Access Compliance Report

Public Rights-of-Way

(Curb Ramps)

Intersection ID: 28378	Main Street: BALDWIN_HALL_DR	Cross Street: SOUTHAMPTON_COMMONS_DR	Location:	N
ADA ID: B887CB1A3242	Ramp Type: Perp	Initial Pass/Fail: Fail	Overall Compliance: No	Severity Score: 25
Codes/Mitigation Info/Possible Solution		Field Measurements/Component Compliance

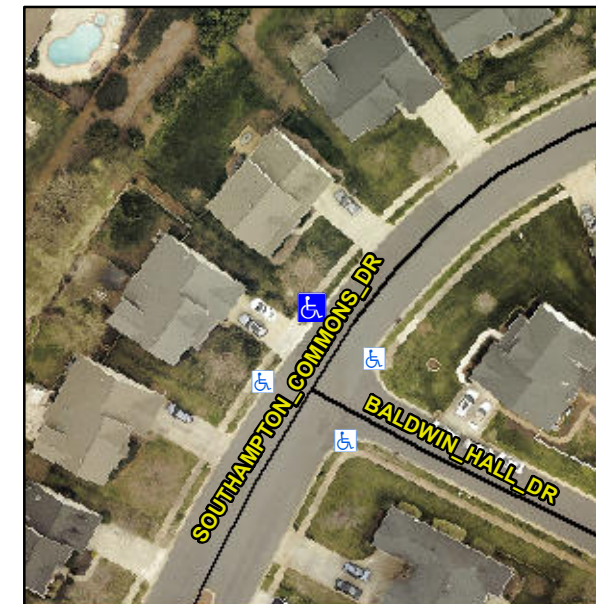
Not Found, R304.2.2, R304.5.3

Compliance	Description	Data	Compliance	Description	Data
N/A	Ramp Length (in)	49.0	No	Ramp Slope (%)	9.2
Yes	Ramp Width (in)	48.0	No	Ramp XSlope (%)	5.1
N/A	Flare Type LT	N/A	N/A	Flare Type RT	N/A
N/A	Flare Slope LT (%)	N/A	N/A	Flare Slope RT (%)	N/A
N/A	Flare Traversable LT?	N/A	N/A	Flare Traversable RT?	N/A
N/A	Landing Length (in)	N/A	N/A	DWS Provided?	N/A
N/A	Landing Width (in)	N/A	N/A	DWS Contrast?	N/A
N/A	Landing Slope (%)	N/A	N/A	DWS Length (in)	N/A
N/A	Landing X Slope (%)	N/A	N/A	DWS Full Width?	N/A
N/A	Landing Curb? (Y/N)	N/A	N/A	DWS Offset (in)	N/A
N/A	Shared Landing?	N/A			
N/A	Gutter Ponding?	N/A	N/A	Gutter Slope (%)	N/A
N/A	Gutter Lip Ht (in)	N/A	N/A	Gutter X Slope (%)	N/A
N/A	Painted X Walk1?	No	N/A	Painted X Walk2?	N/A
	X Walk 1 Direction	To SE		X Walk 2 Direction	N/A
N/A	X Walk 1 Width (in)	N/A	N/A	X Walk 2 Width (in)	N/A
	X Walk 1 Slope (%)	0.6		X Walk 2 Slope (%)	N/A
	X Walk 1 X Slope (%)	4.5		X Walk 2 X Slope (%)	N/A

Remove & Replace Entire Ramp.
